# **Upgrade Information of MPE720 Version 5.41**

## 1. Added and Improved Functions

Items added and features improved from MPE720 version 5.40A to version 5.41 are as follows.

## No.1 Support to MP940 of application converter.

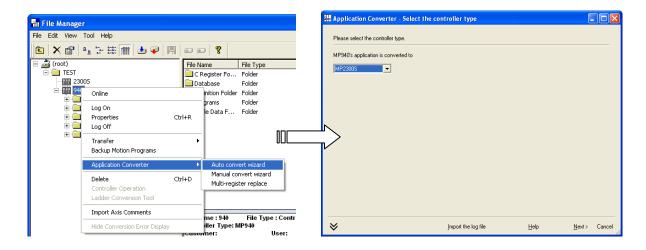
MP940 can be selected at target of automatic conversion in the application converter.

Target controller: MP940/ MP940M/ MP940D

MP940	Enable to convert
WIP940	to MP2000 series controller
MP940/MP940M	MP2300
	MP2310
	MP2300S
MP940D	MP2300
	MP2310

- \*: S drawing is cannot be converted in the MP2000 series.
- \*: S register is without target of application converter.
- \*: S scan is converted into H scan when converting to the MP2000 series.
- \*: MLINK definitions of MP940M is converted into M-II (32 byte/ 0.5ms) in the MP2300S.

I/O modules allocated to MLINK definition are converted into \*\*\*\*\* I/O when there is no convertible M-II compatible module, because I/O module cannot use in the M-II.
- \*: When 261IFS has been selected of 6th slot of MP940, it is without target of application converter.

## No.2 Support to Comparison processing of table data.

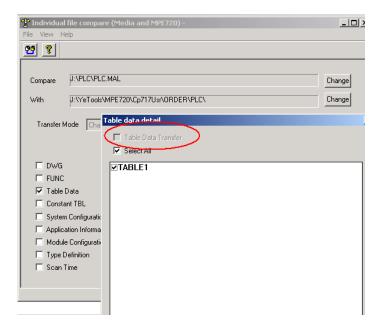
Both online/ off-line table data were added to the comparison target though data table was without target of the comparison.

#### No.4 Bug of start from User Menu (SVB)

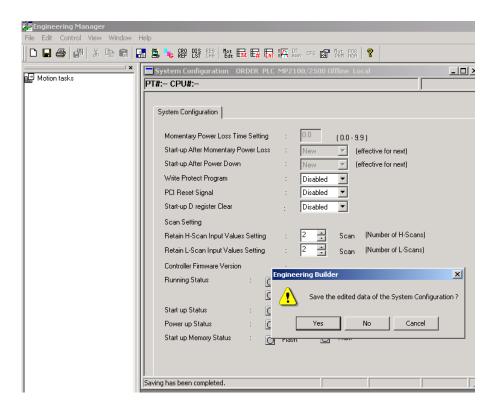
It was modified because "Don't support module." was displayed when SVB detailed definition screen was register with user menu and SVB detailed definition screen was started from the user menu.

And it was modified that the same message was displayed when the tab of the parameter of SVB detailed definition screen which started from the user menu was switched.

#### No.7 Bug of Input/ Output disable operation of I/O message communication.

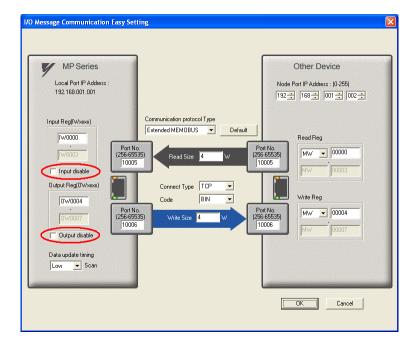
The operation of "Input disable" and "Output disable" were different on I/O message communication of 218IFA detail definition window.

"Input disable" is the check box is checked, the check is maintained until the check box is cleared. But "Output disable" is the checkbox will be unchecked when "Protocol type" is changed or "Default setting" button of the Easy Setting is clicked. So, The value of "Output disable" was not cleared with the "Default" transaction when "Protocol type" is changed or "Default setting" button of the Easy Setting is clicked.

## No.9 Bug of unit of display of SVB linear type for MP2310/ MP2300S.

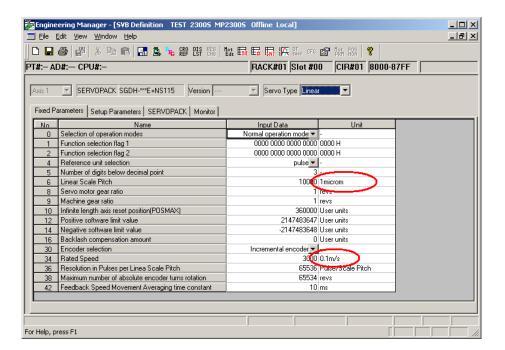
It was modified that when the Servo Type of motion parameter of SVB was set in the Linear, the unit of No.6 "Linear Scale Pitch" was displayed by mistake as "microm". And, it was modified that the unit of No.34 "Rated Speed" was displayed by mistake as "0.1m/s".

## No.10 Bug of the fixed parameter input range.

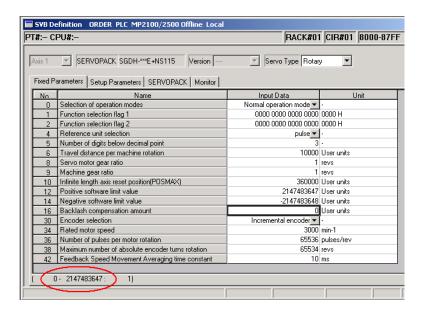
It was changed from "0 to 2147483647" to "-2147483648 to 2147483647". Because the setting range of the Fixed parameter No.16 "Backlash compensation amount" of MP2100 built-in SVB was "0 to 2147483647".

## No.12 Bug which using one-byte katakana in the motion program.

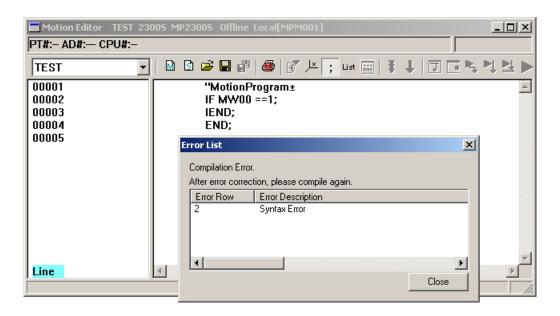
It was modified that it was likely to become an error when saving or wrong code is generated occasionally which using one-byte katakana (character code is 0x80 or more) in the motion program.
